Re: ACT 007/019, Incidental Boundary Change, Remote Fan Installation

APPLICATION FOR PERMIT CHANGE

DATE RECEIVED	9/12/94	PERMIT NUMBER	ACT/007/019
Title of Proposal:	Ibe, Remote	PERMIT CHANGE #	946
Description:	Fur Installation	PERMITTEE	Judalex
		MINE NAME	Centennial

Aberdeen Mine
 Left-Hand Fork
 Fan Installation

Exhibit B

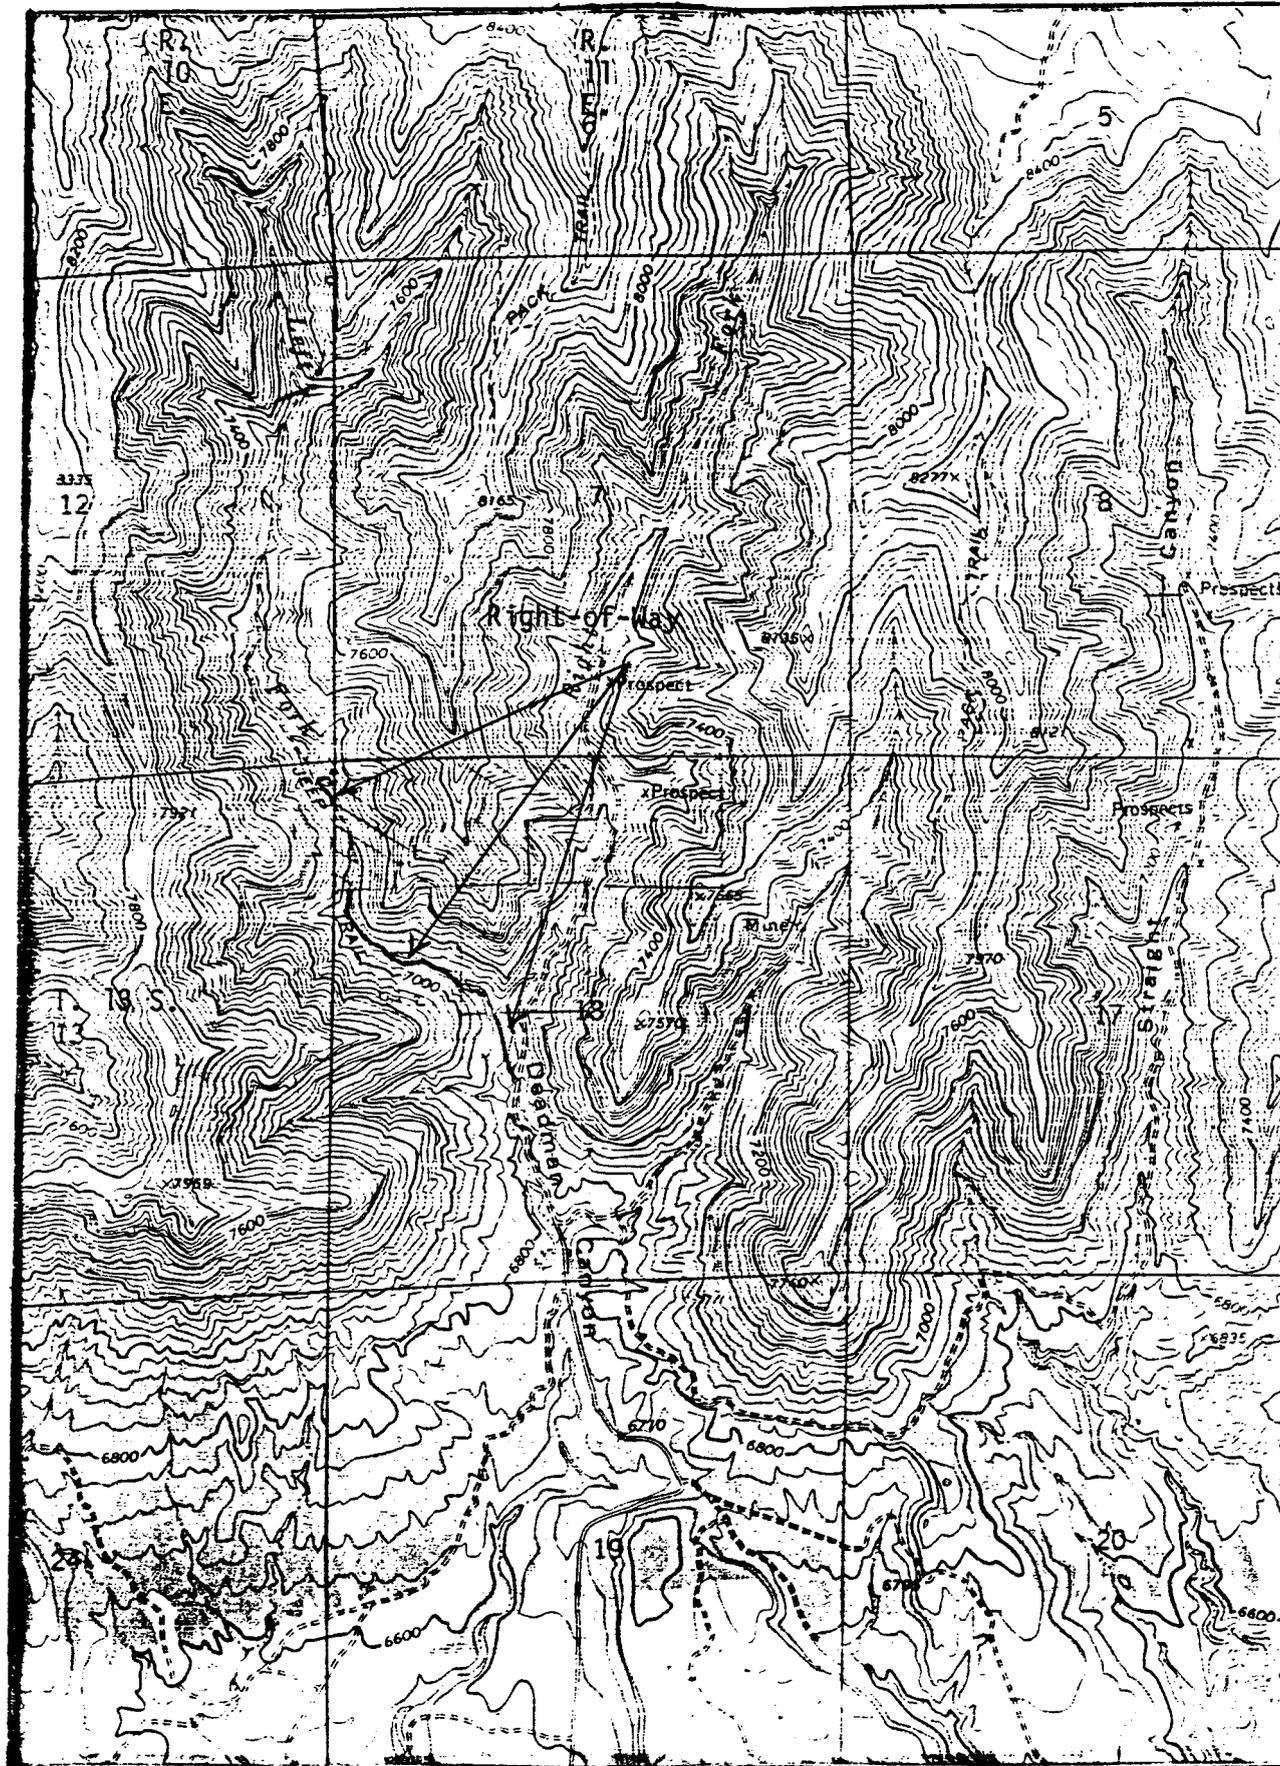
Deadman Canyon 7 1/2 Minute Quadrangle showing right-of-way location.

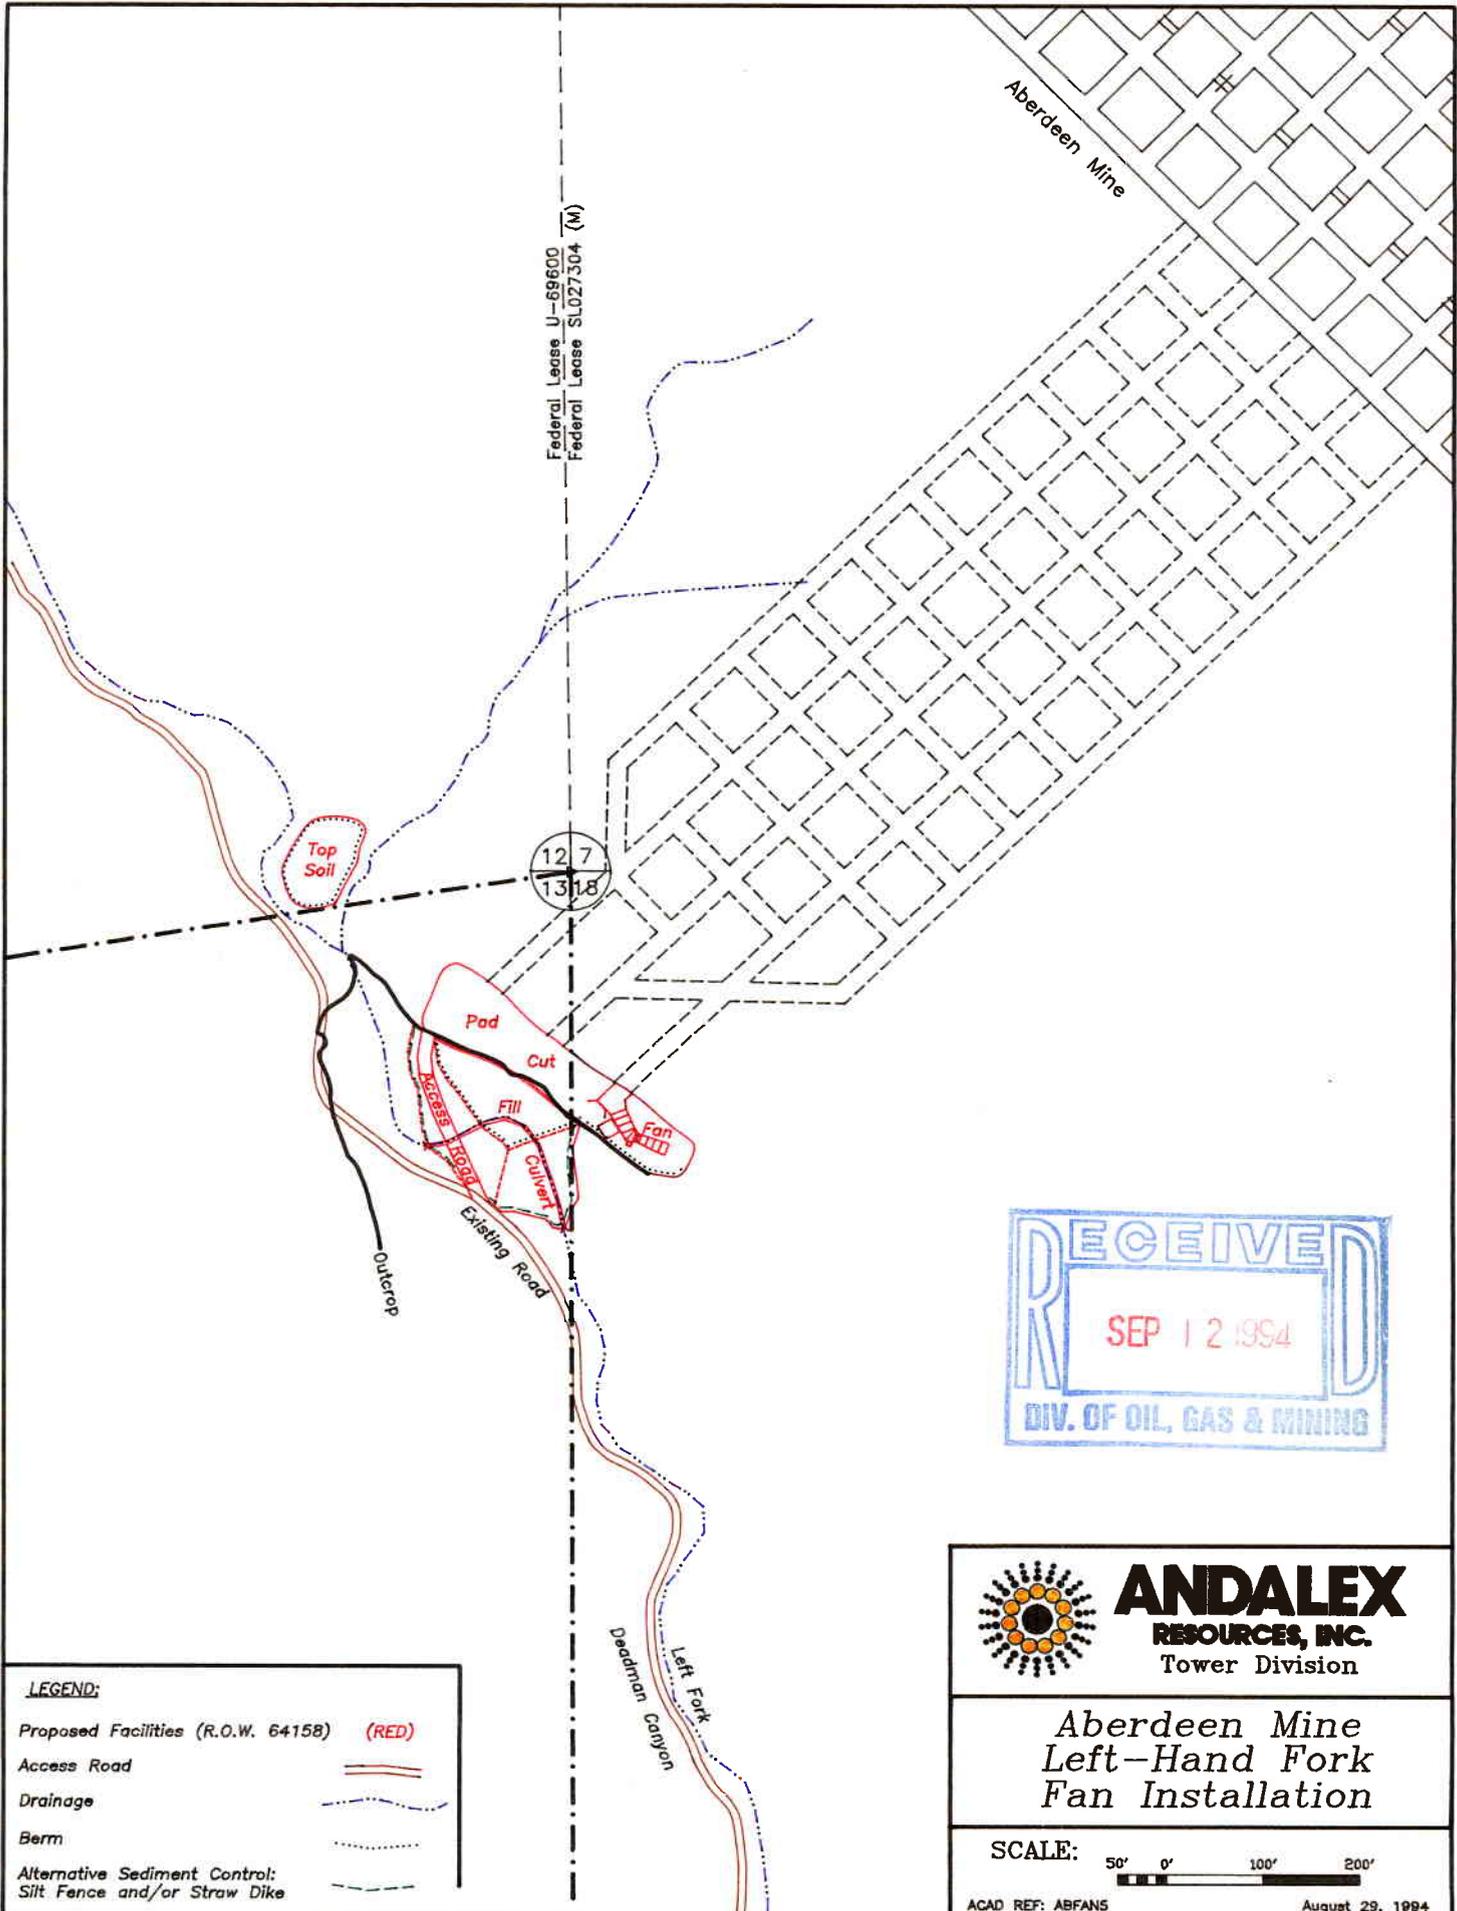
Enclosed are three copies of plans for construction of a pad and remote ventilation fan installation in the left-hand fork of Deadman Canyon.

Andalex views this installation on its BLM right-of-way U-64158 as an incidental boundary change and we are anxious to begin construction as soon as possible.

Description, include reason for change and timing required to implement: Longwall mining in the Aberdeen Mine will require an increase in ventilation. It is proposed to accomplish this through the use of an additional fan. Timing is this construction year.
